CITY OF ALBUQUERQUE

**RE: 629 57th Street NW
Grading & Drainage Plan
Engineer's Stamp Date: 6/6/25
Hydrology File: J11D046
Case # HYDR-2025-00204**

Based upon the information provided in your submittal received 6/06/2025, the Grading plan is **approved** for Grading Permit and Building Permit. Please attach a copy of this approved plan in the construction sets for Building Permit processing along with a copy of this letter.

ENGINEER'S SEAL	629 57th STREET	DRAWN BY DEM
DAVID SOULE NEW MEXICO REGISTERED PROFESSIONAL ENGINEER 14522 6/6/25		DATE 10-12-23
DAVID SOULE P.E. #14522	GRADING AND DRAINAGE PLAN	629 57th St. DWG
		SHEET # C1
		JOB #

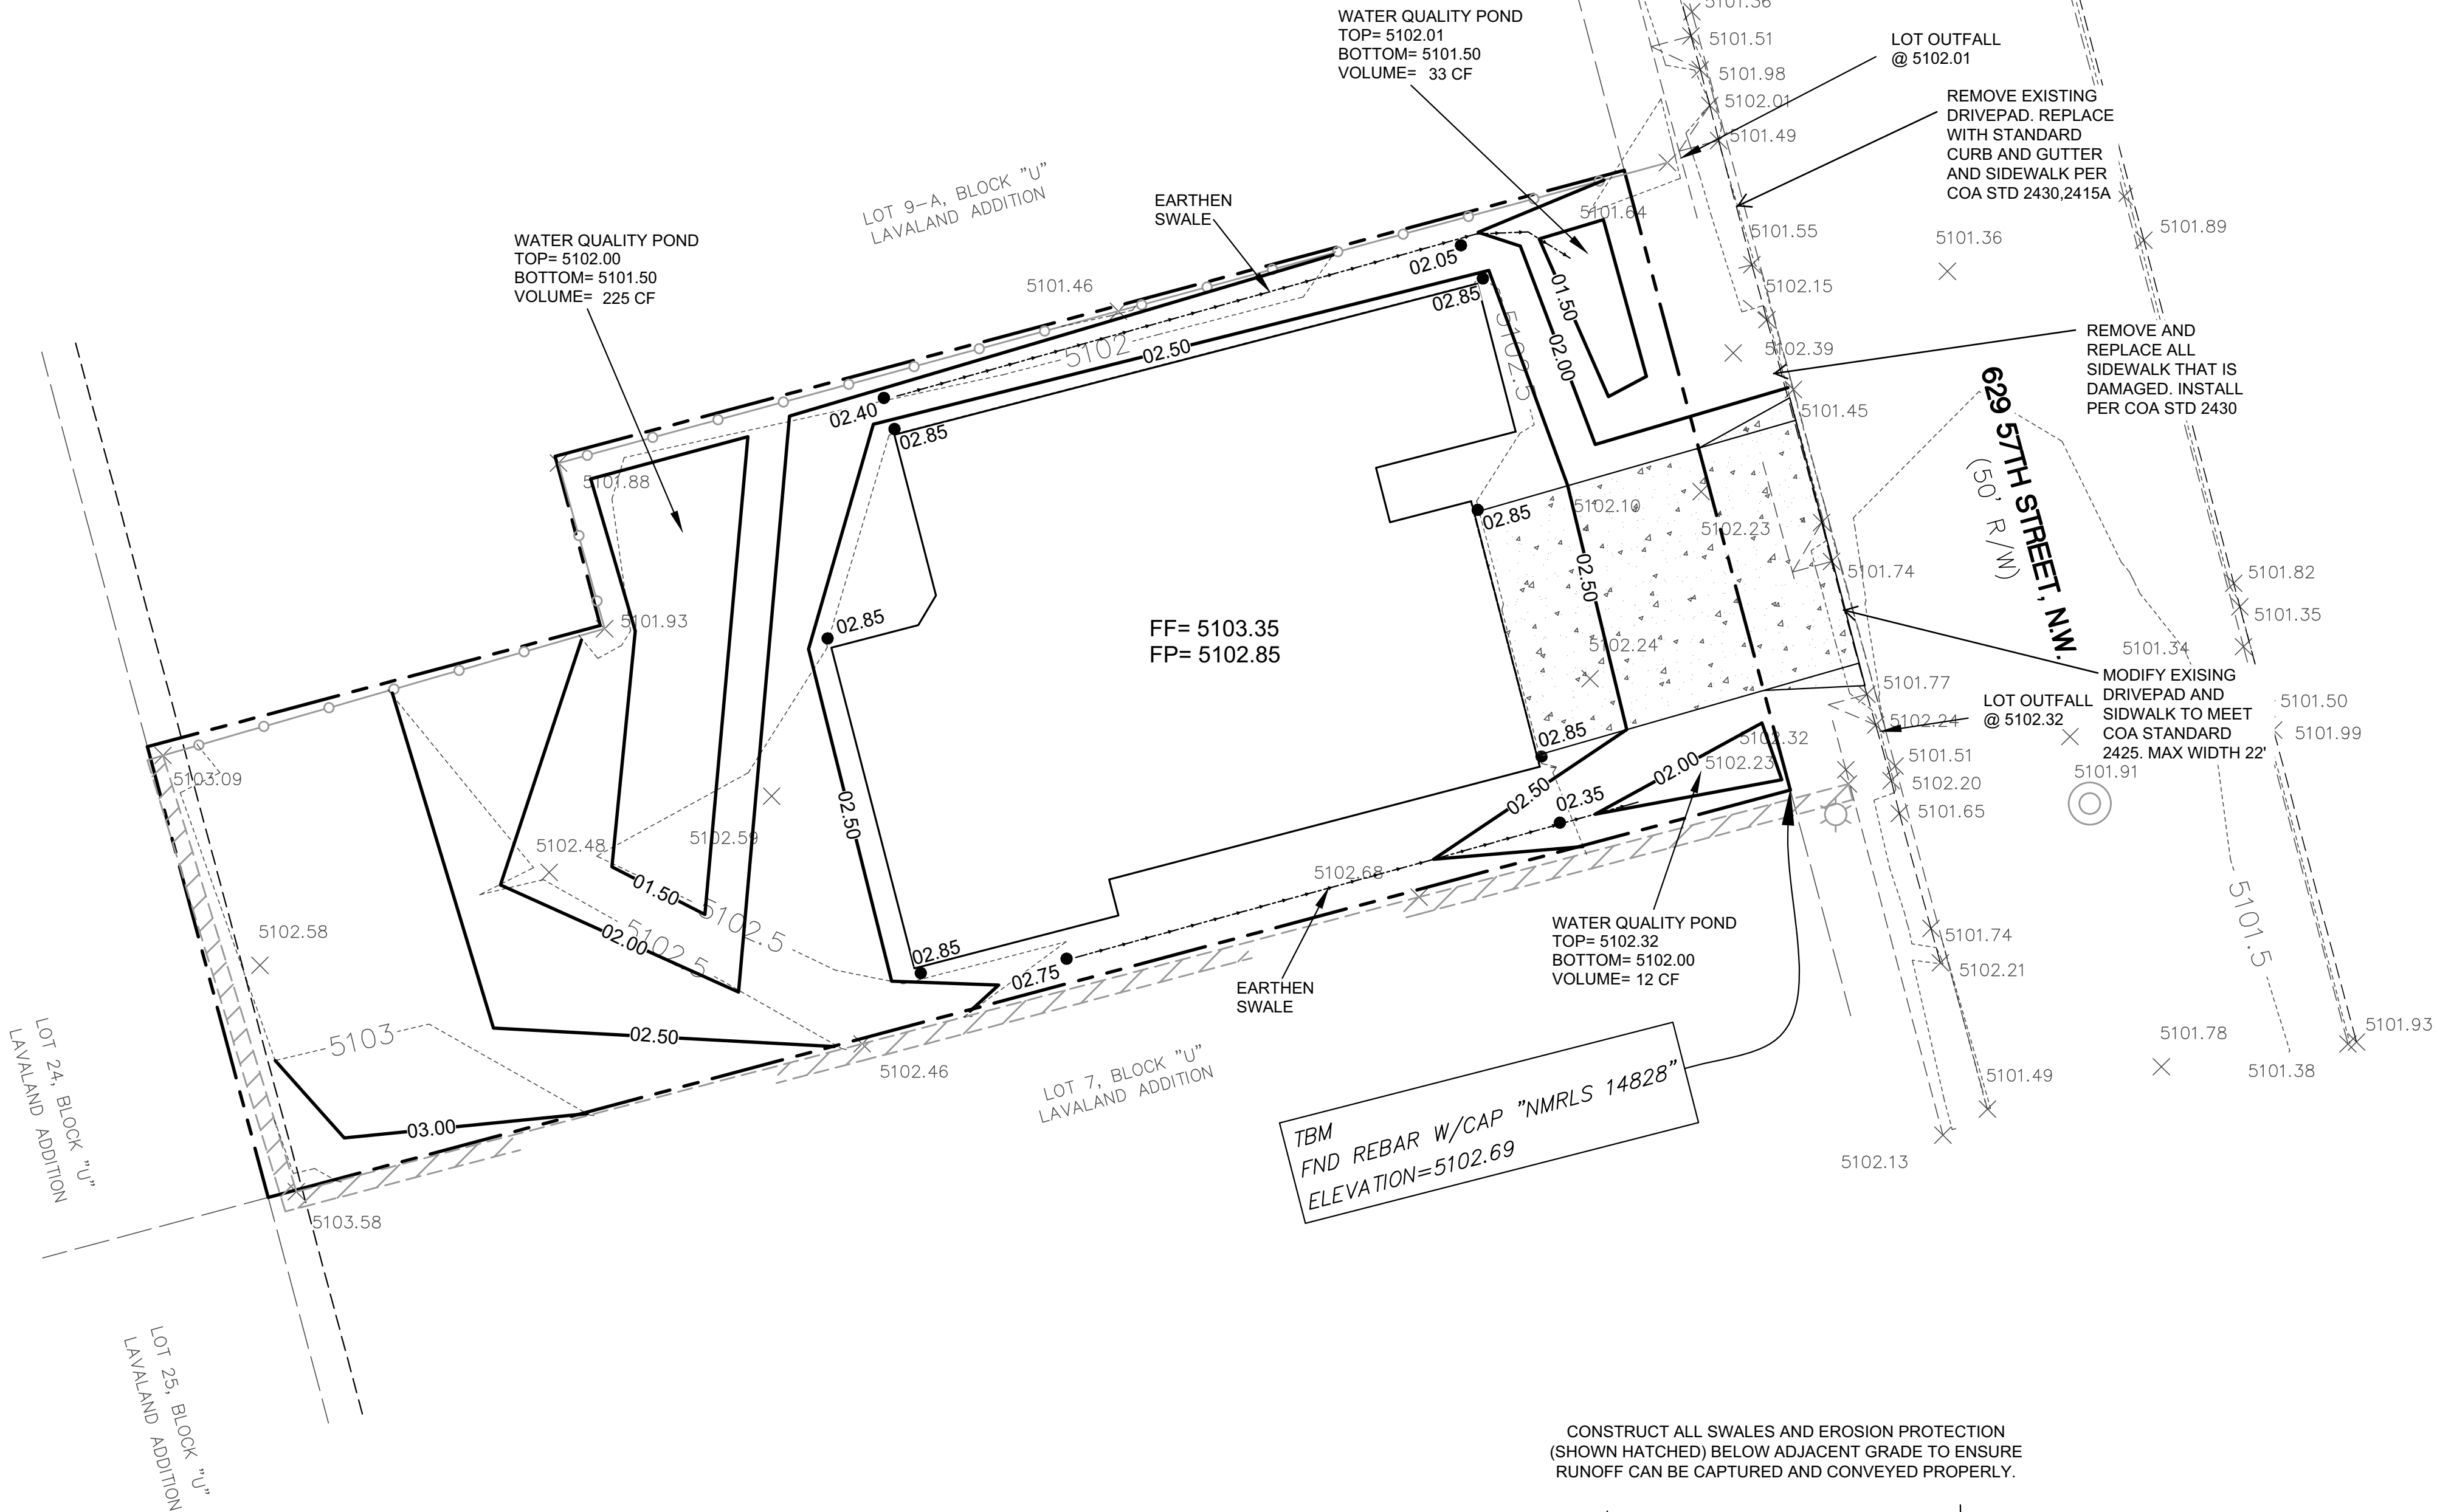
1. Engineer's Certification, per the DPM Part 6-14 (F): *Engineer's Certification Checklist For Non-Subdivision* is required.
